Item: 9

DC/24/0773/VOC

Variation of Condition Nos. 4 (materials) and 9a (approved plans for residential development) of DC/23/0539/VOC - Changes to materials for residential units and amendments to approved plans including changes to elevations and revisions to site layout and parking.

Former Deben High School, Garrison Lane, Felixstowe

(Shown here – House Type 02)

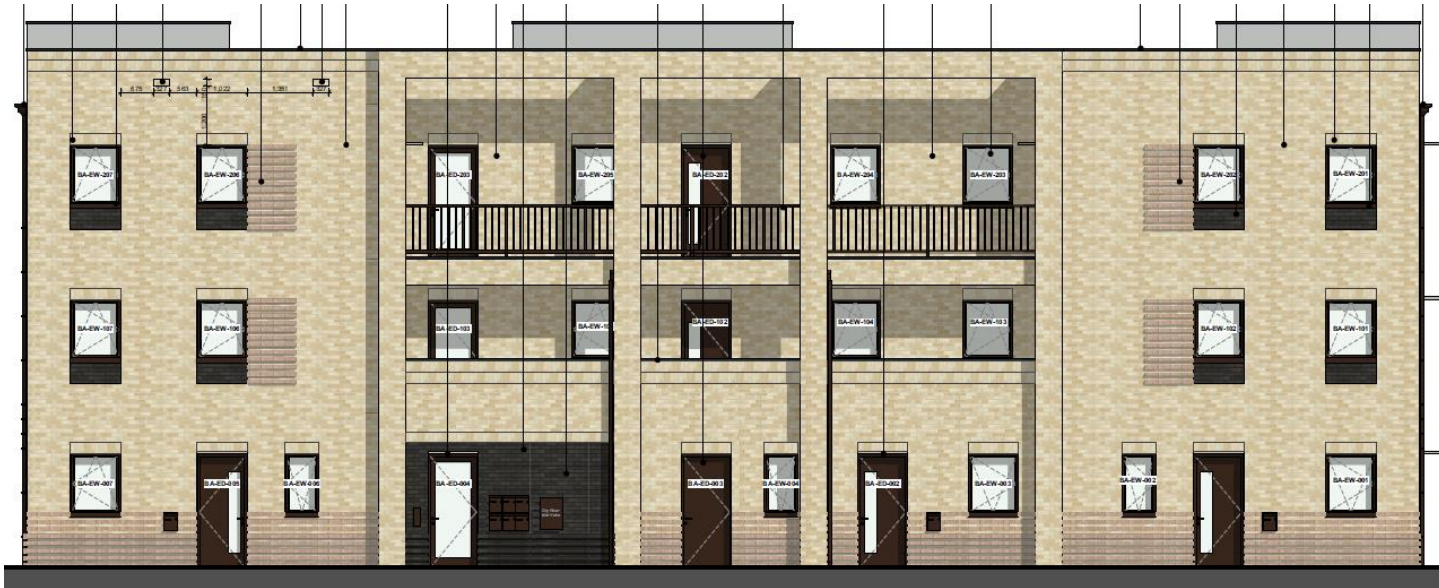
- Reduced window sizes with contrasting black brick recessed panels proposed below windows
- Provision of external rainwater goods
- Removal of glass reinforce concrete window sills, brick soldier courses proposed above windows

(Shown here - Block A, northeast elevation)

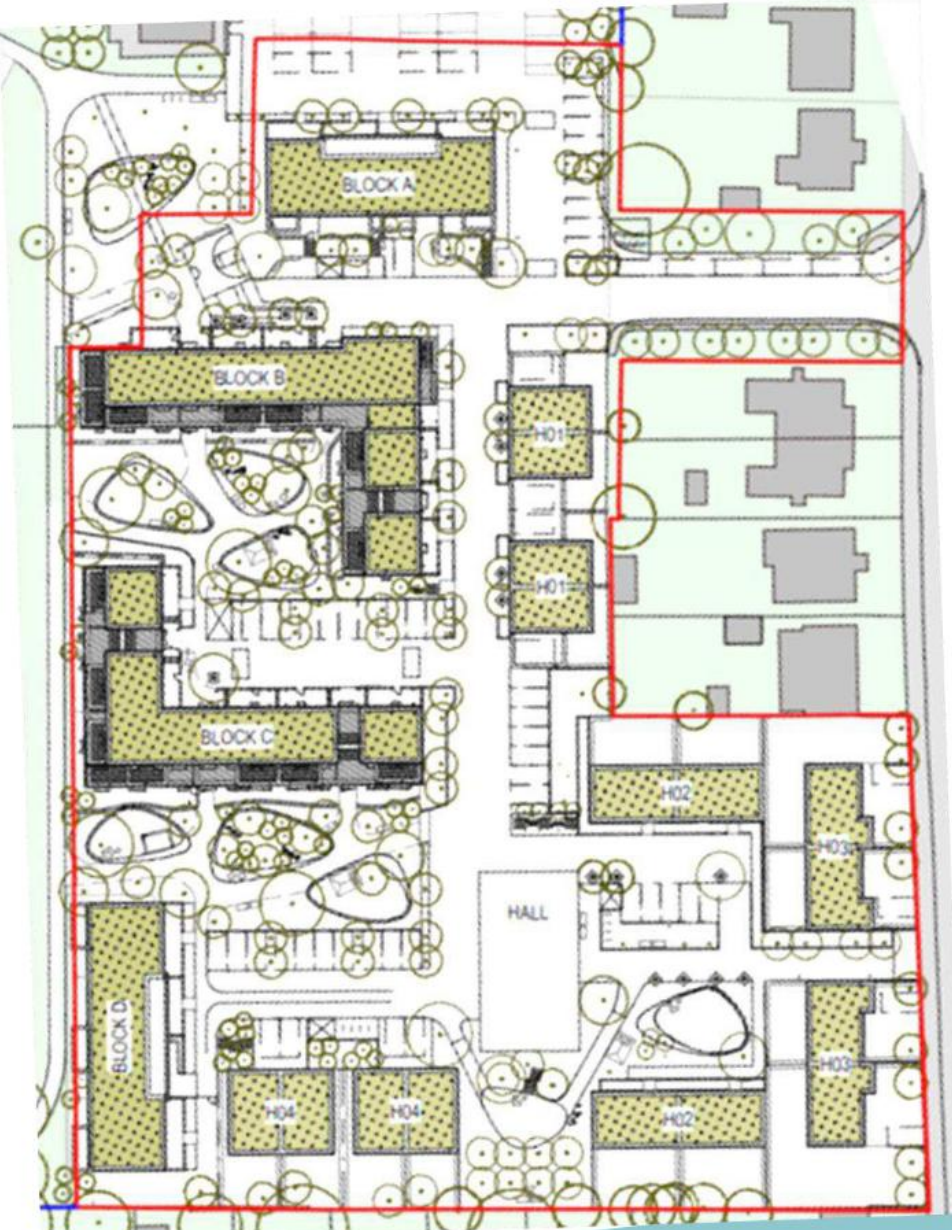
- Changes to main entrances of Blocks A and D to no longer be recessed, and material changed from metal cladding to brickwork. Black contrasting bricks to be used in these areas to highlight the main entrances.
- Brick slips to be used on some areas of the apartment blocks, in lieu of full brick, to reduce weight on the timber frame structures.

Amendments to House Type 01 (Northwest, front elevation)

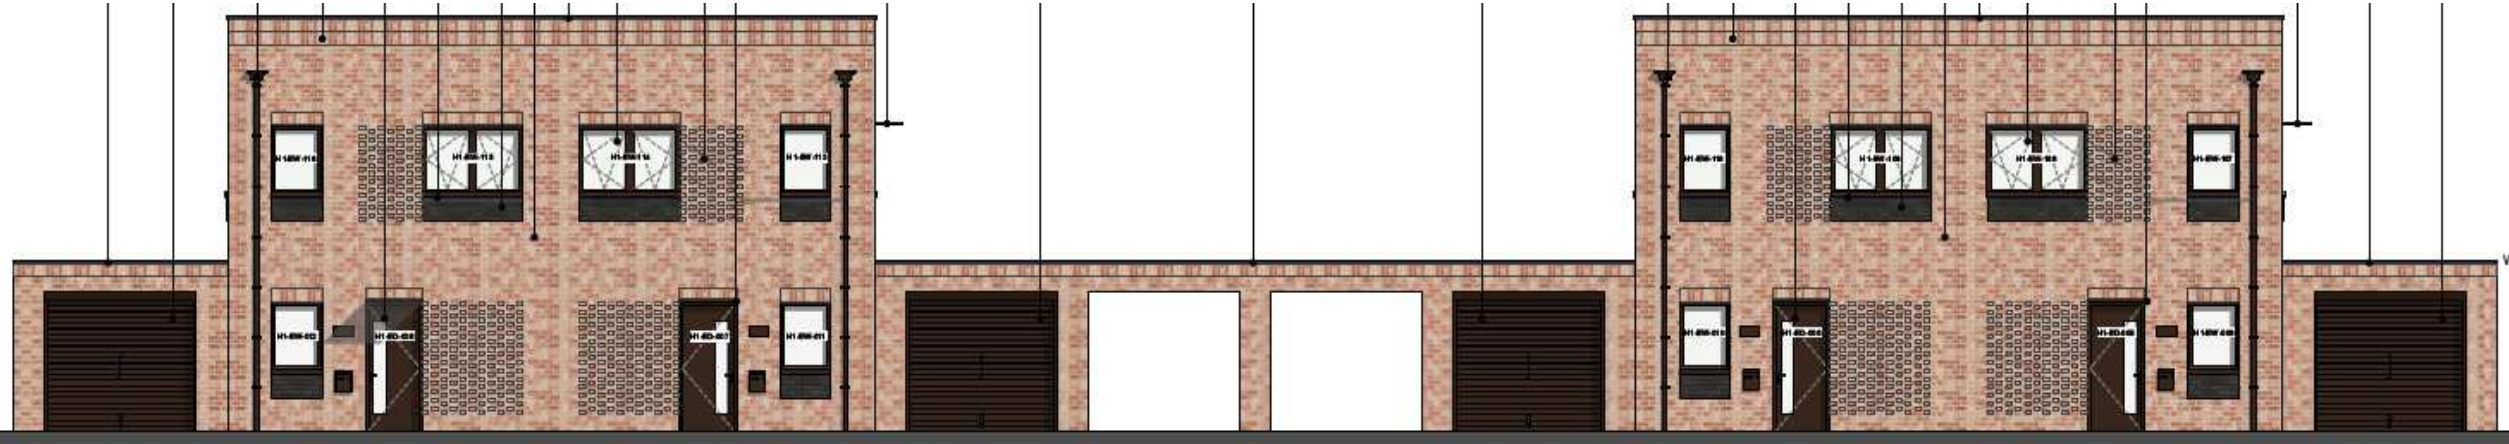
Amendments to House Type 01

Amendments to House Type 01 (Southeast, rear elevation)

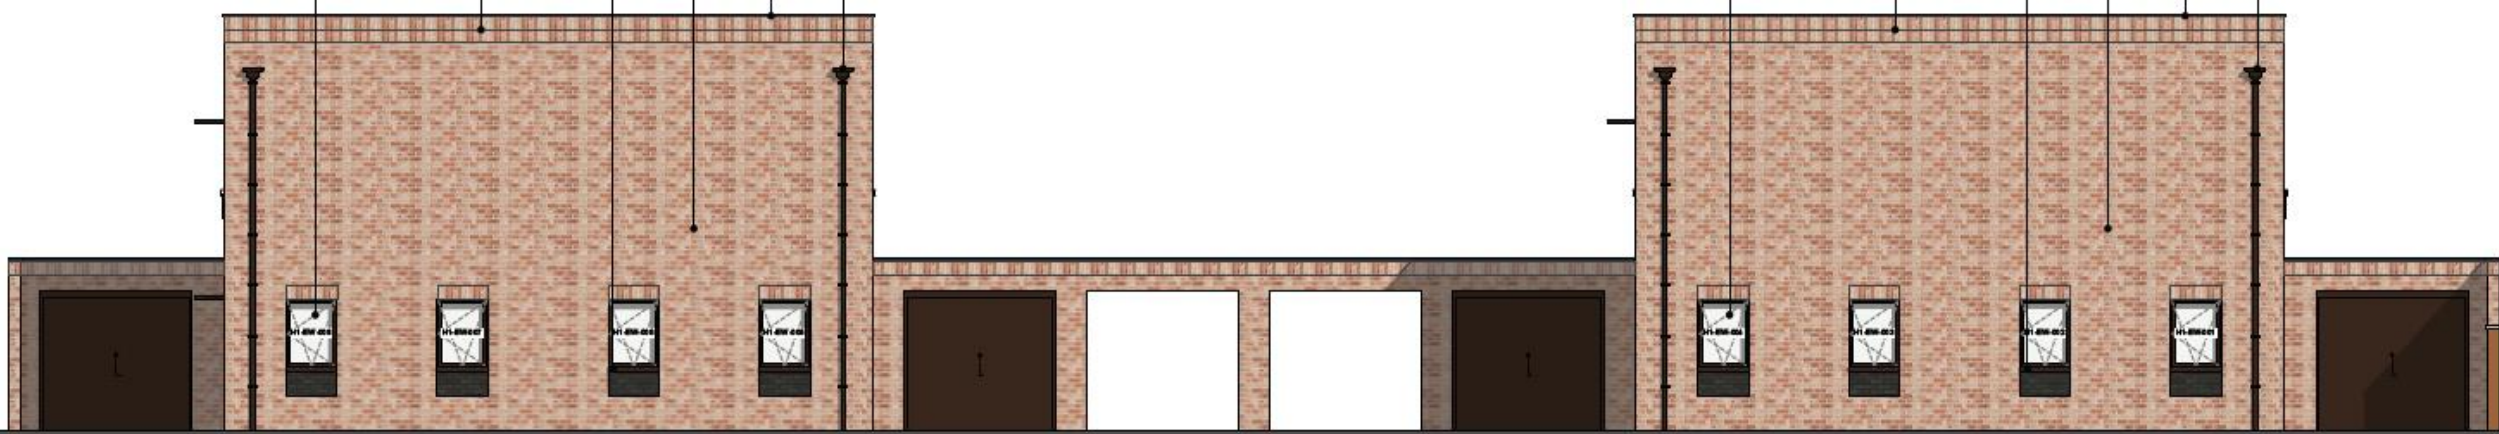
Amendments to House Type 01

Site Section North East to South East

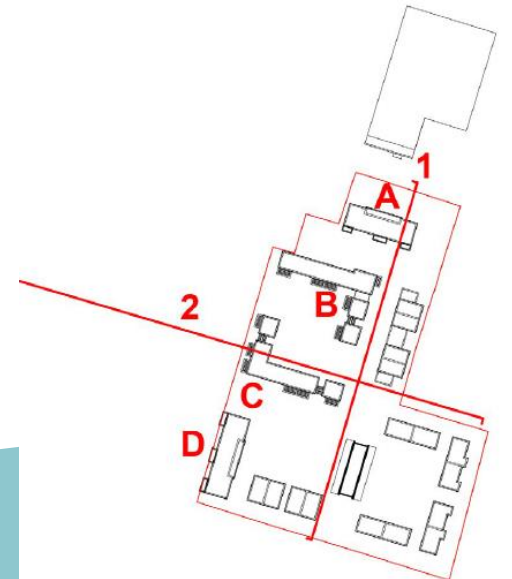
- Approved plans assumed a flat, level site.
- Illustration above shows that finished levels of Block D are lower relative to Block C.

Other changes to layout

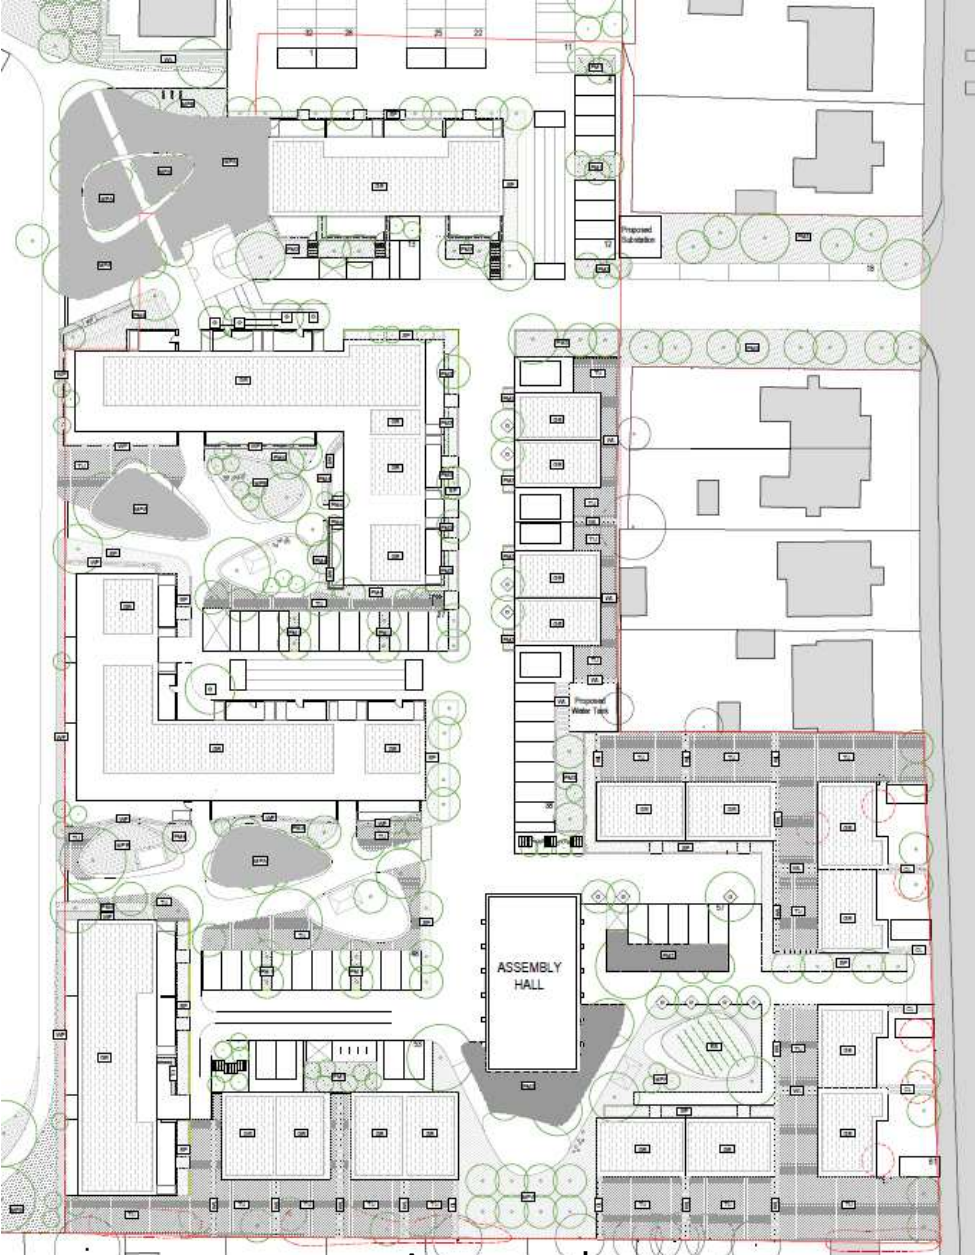
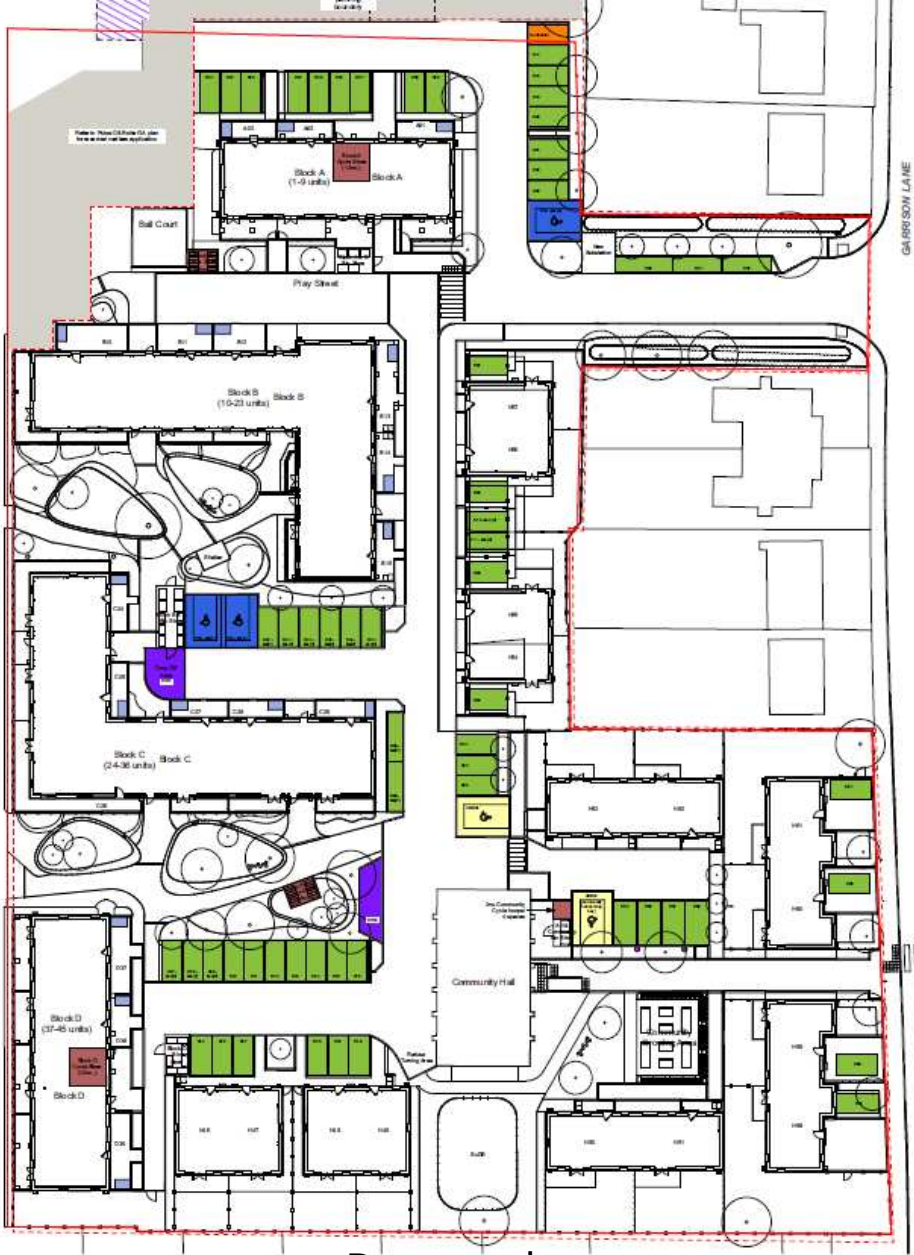
- Parking spaces increased in size, some reduction in soft landscaping as a result
- Reduced parking along access road
- Two drop off spaces, contractor space and blue badge visitor space provided
- Minor changes to siting of substation, ball court, bin stores and cycle stores

Other changes to layout

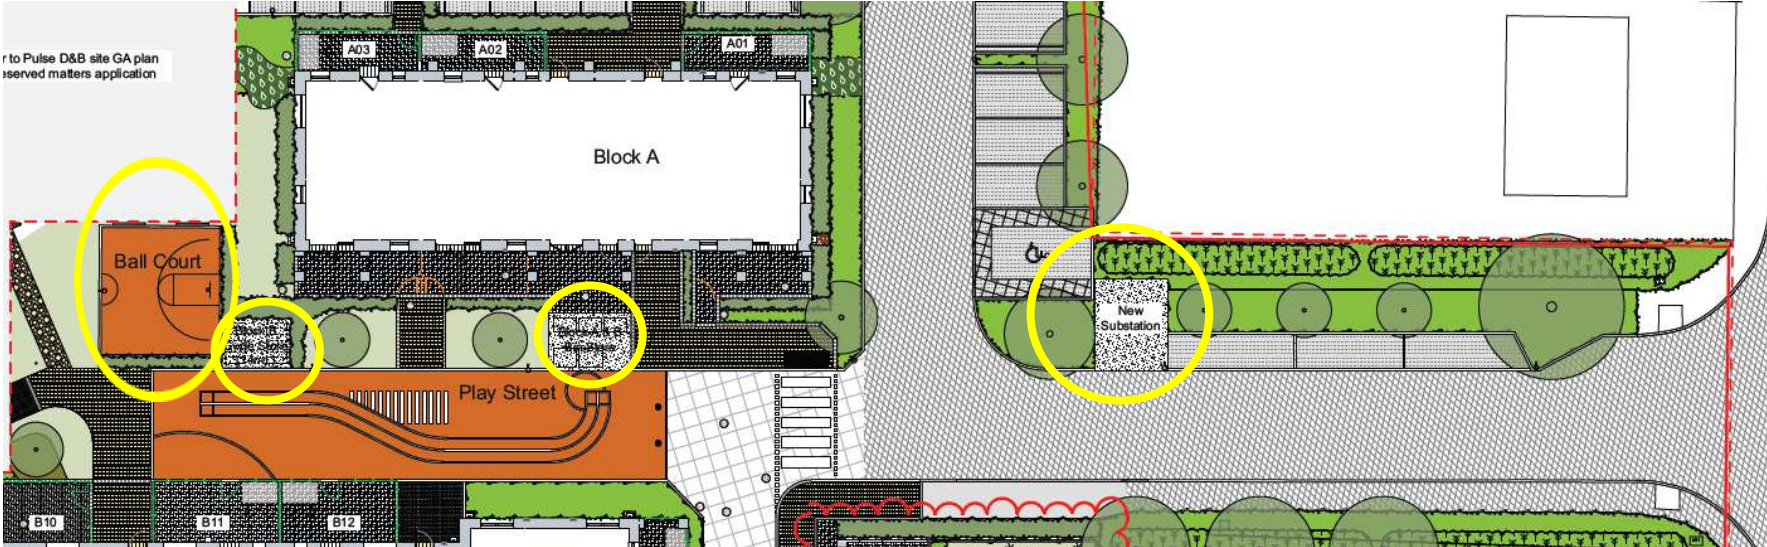
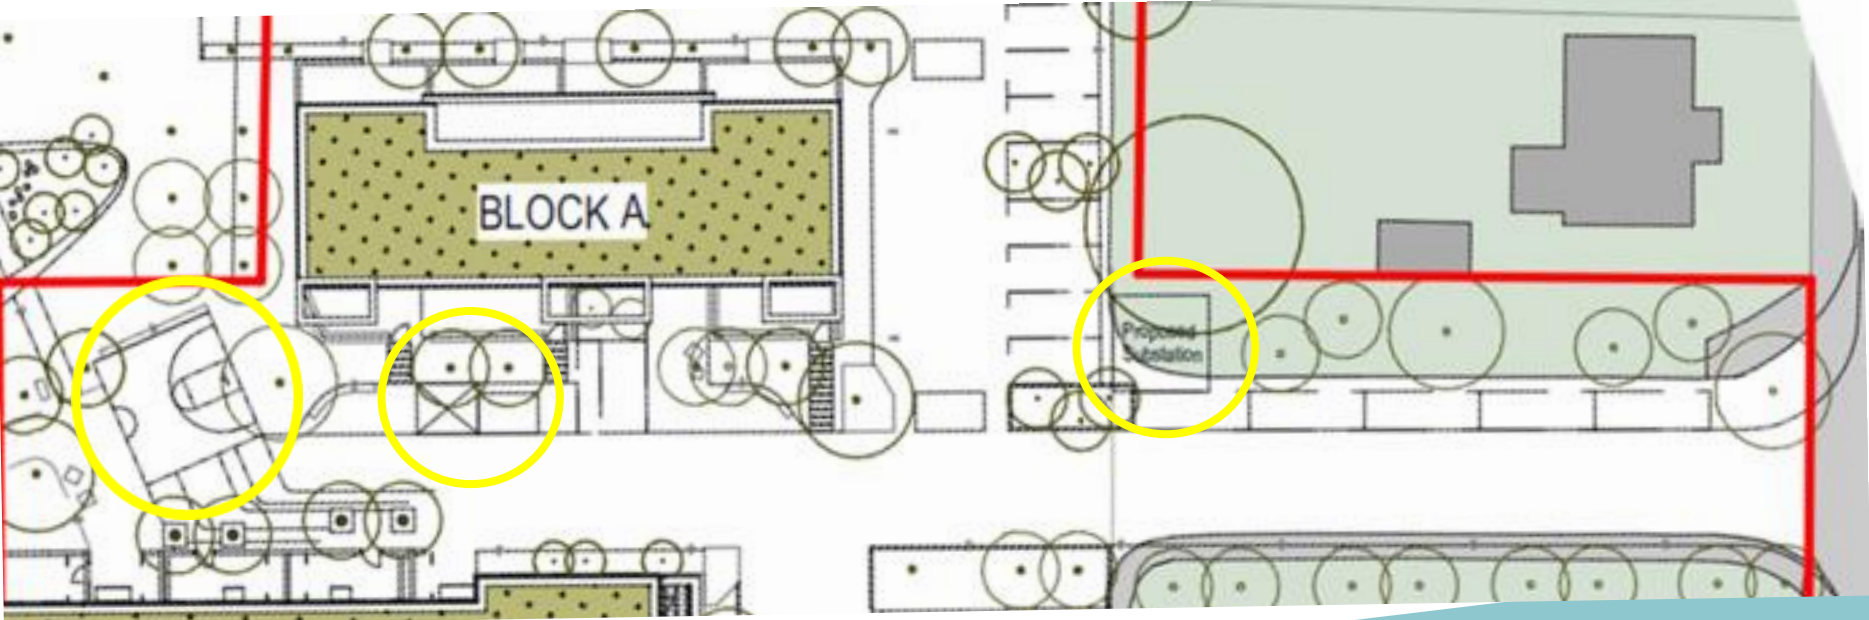
- Reduced parking along access road
- Changes to siting of substation, ball court and bin and cycle stores south of Block A

Other changes to layout

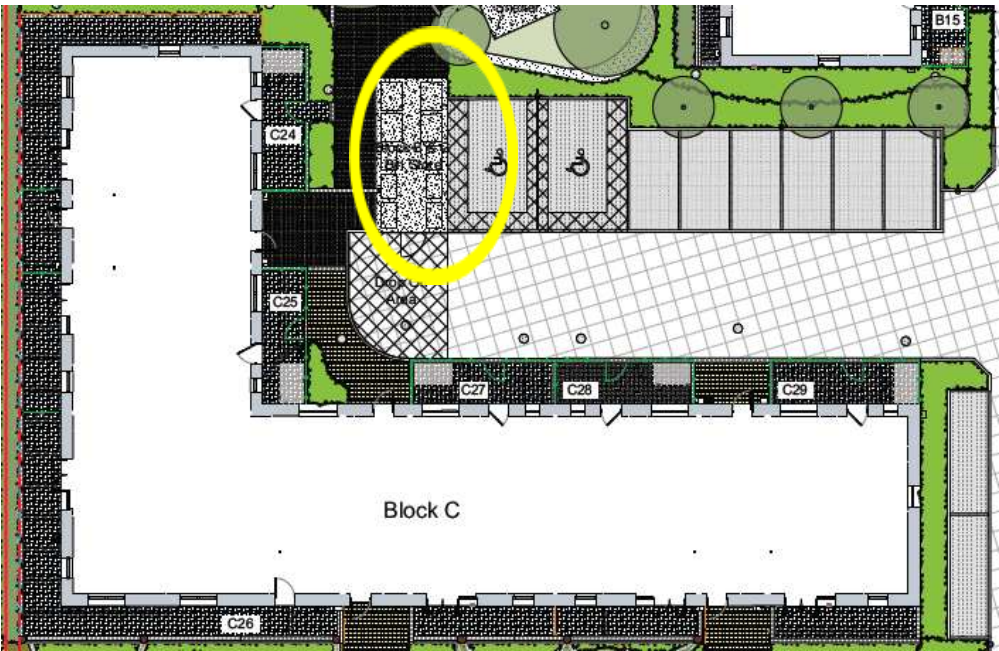
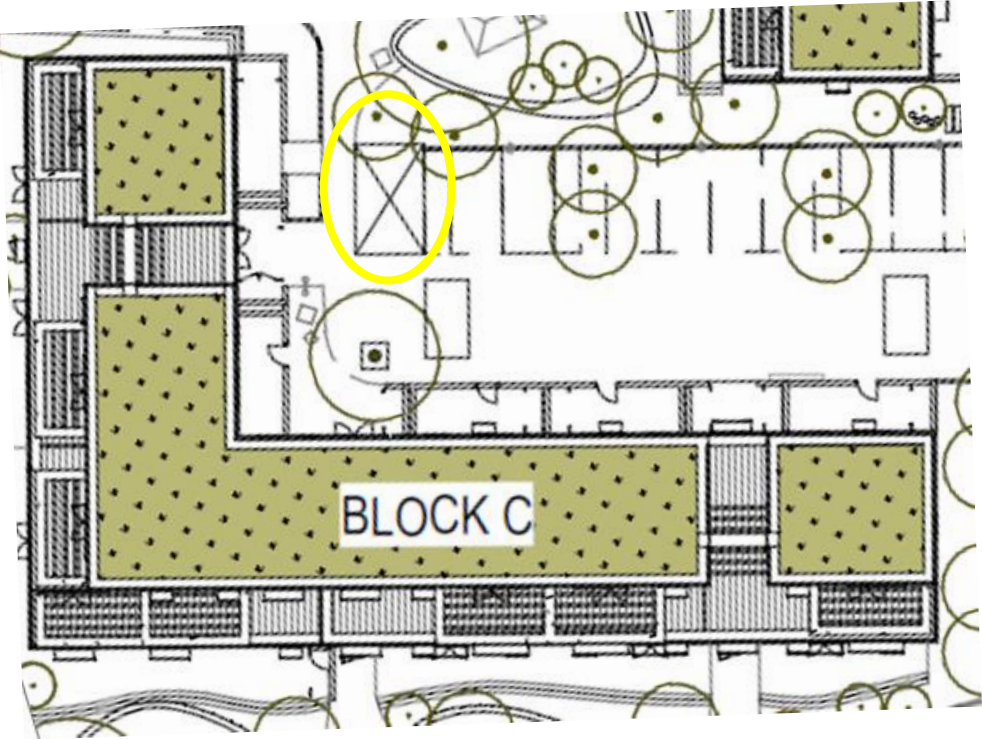
- Bin store north of Block C enlarged
